Revisions to Design Review Board Comments

1st DRB Meeting Date: July 12, 2016

Proposed Development: A.T. Still University Expansion
5850 E. Still Circle

P&Z Case No.: Z16-017

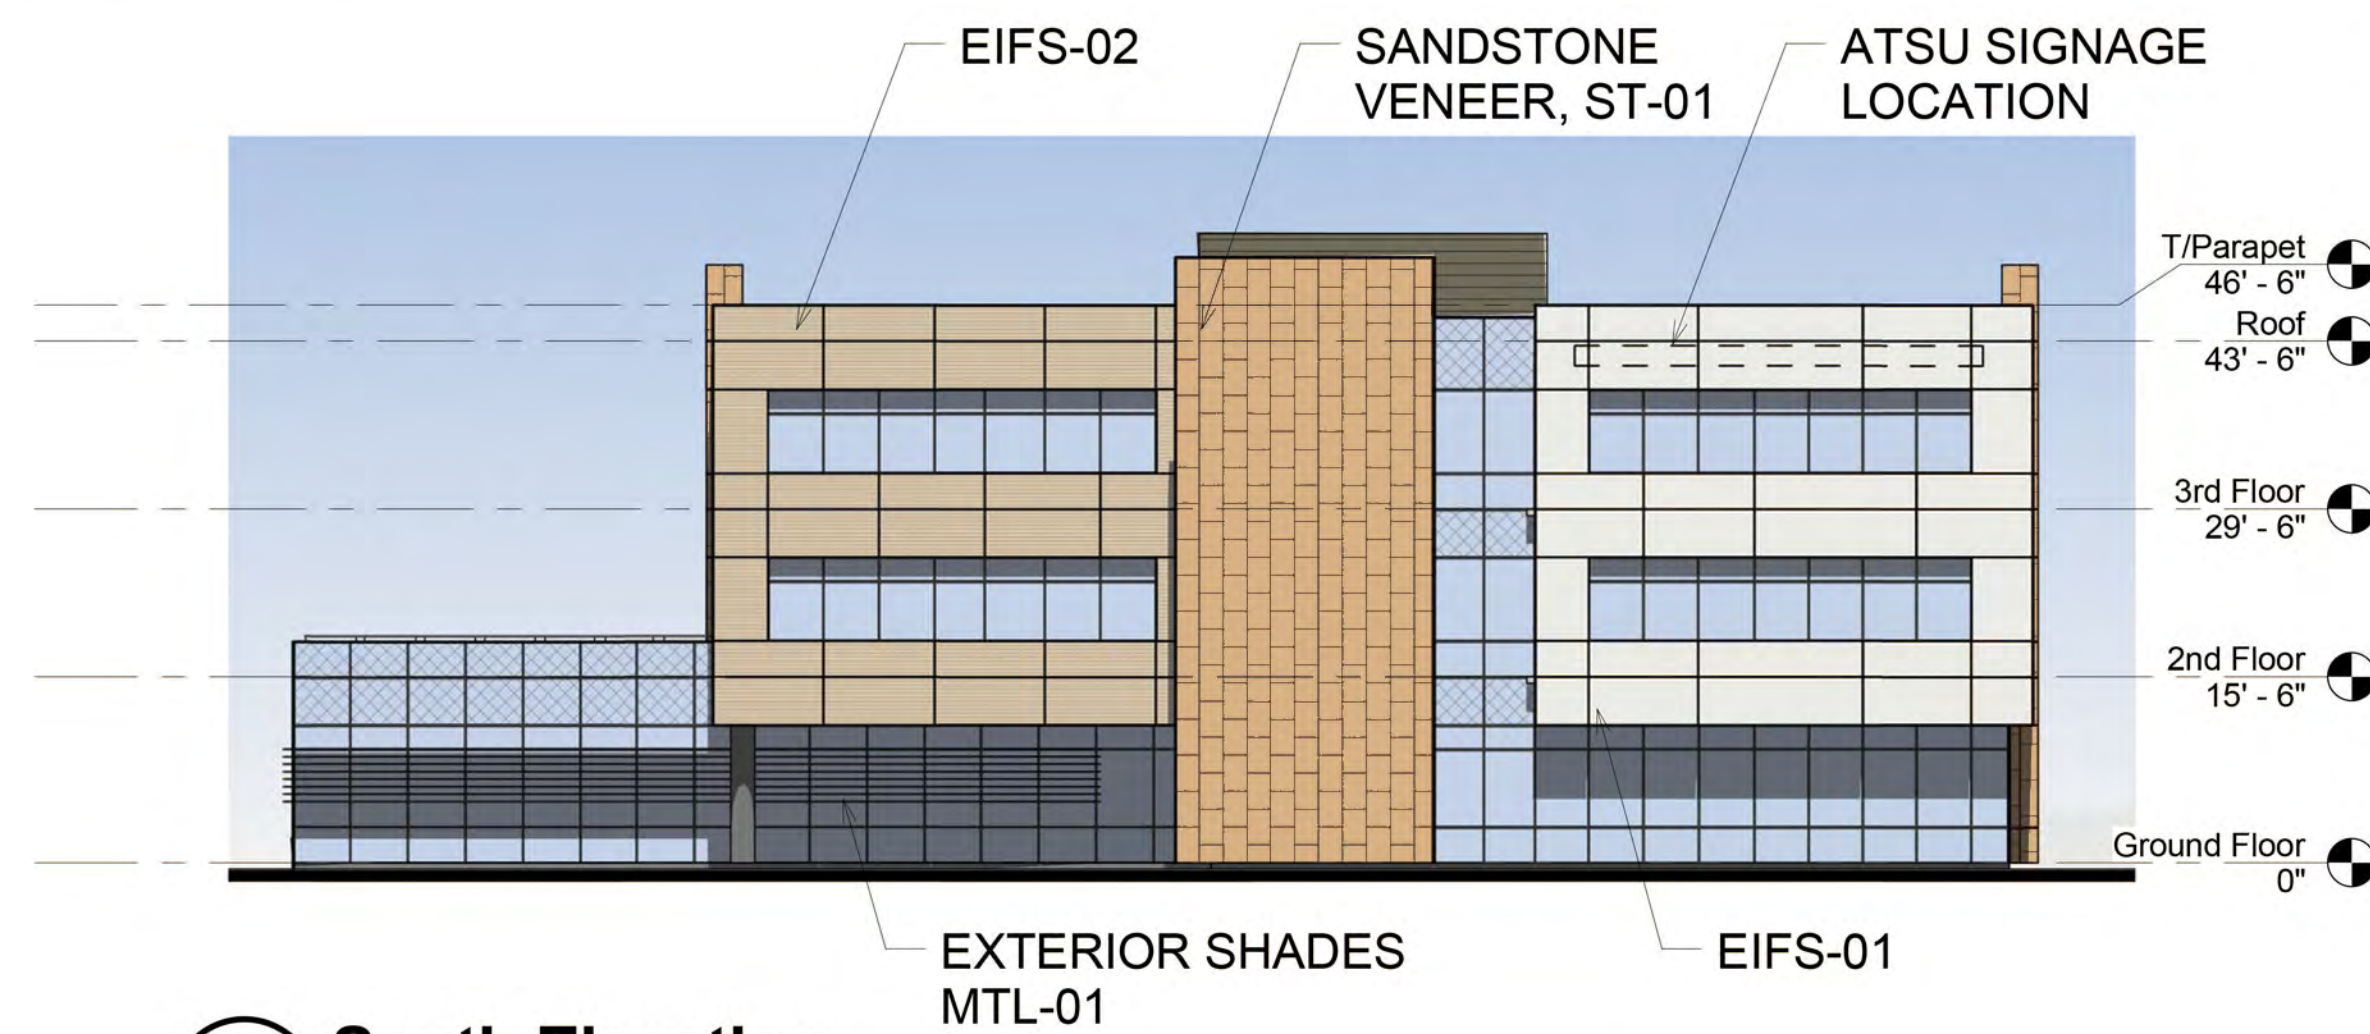
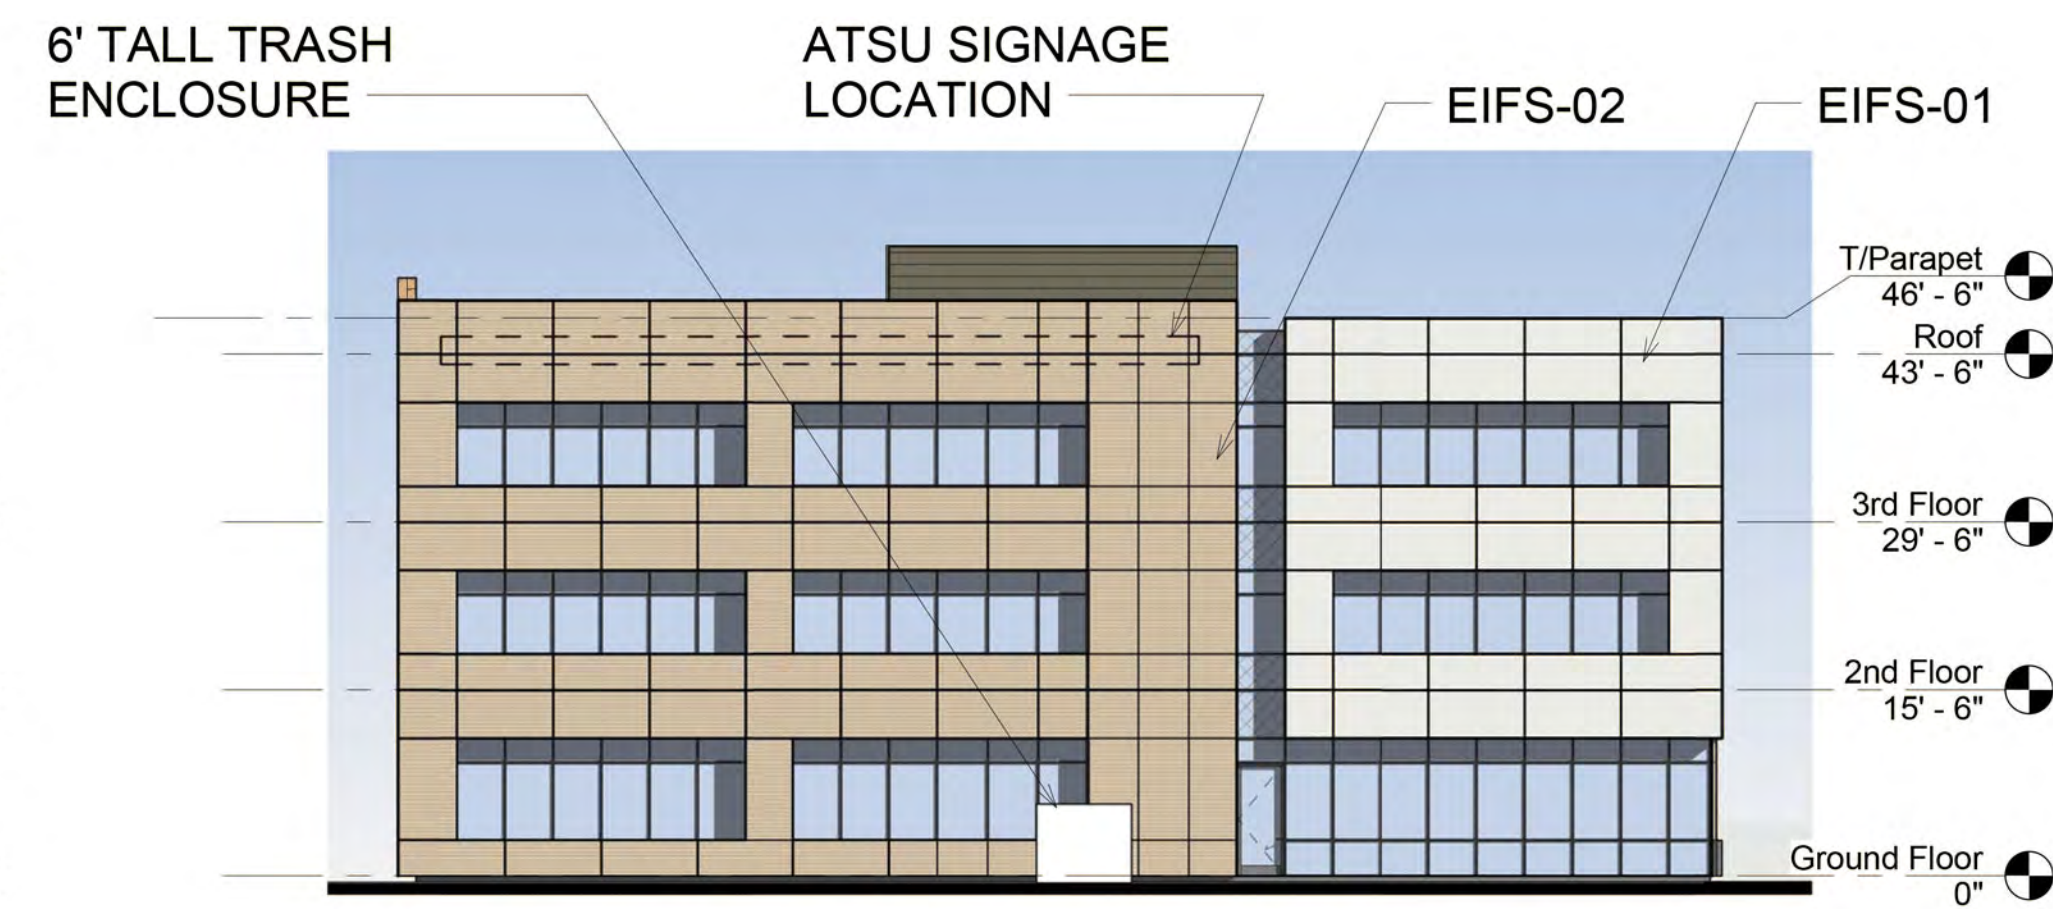
- Length would be better if windows were smaller and different dimensions. [have revised punched openings at the sandstone areas to provide more variation in sizes.](#)

- Change at the sandstone to make changes to windows; use smaller punched openings [have revised punched openings at the sandstone areas to provide more variation in sizes.](#)

- Raise sandstone to height of mechanical [have raised sandstone to what we feel is appropriate height, keeping in mind you won't see the mechanical screen from the street in context with the sandstone.](#)

- Trouble with the building in severity of it's planes
- Agrees likes the sandstone [okay](#)
- Does not see the eyebrows 1 ½ on [added better definition of shade at glass setback to new elevation](#)
- Severity of the white eaves and looking at original building ; comparing to ASU Polytech building feels there is a lot more that could be done with this building to help differentiate the planes Not seeing movement on the building [see enlarged rendering. There is subtle stepping of glass, sandstone and EIFS planes. The center breezeway steps at each floor and is curved, further breaking the mass of the elevations.](#)

1 West Elevation
SCALE: 1/16" = 1'-0"

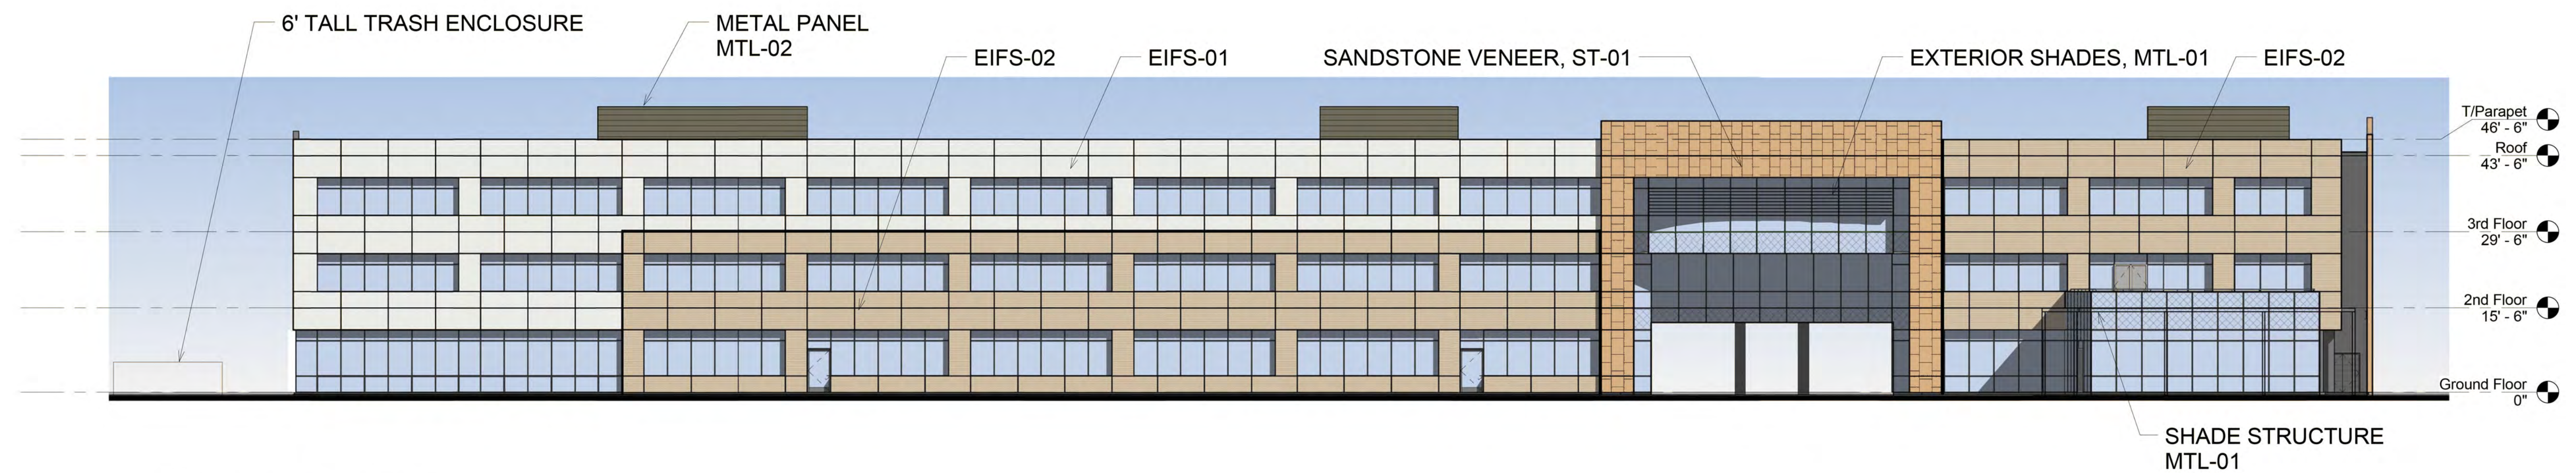
- Asked about shade relief on the west elevation on the windows. Applicant 1 ½ brow and large canopy [shadow lines added to elevations to help delineate glass setbacks](#)

- Lengthen sandstone on west elevation of academic building [have added smaller punched window openings. Want to be careful to balance the sandstone portal element to emphasize the breezeway portal element on both east and west elevations](#)
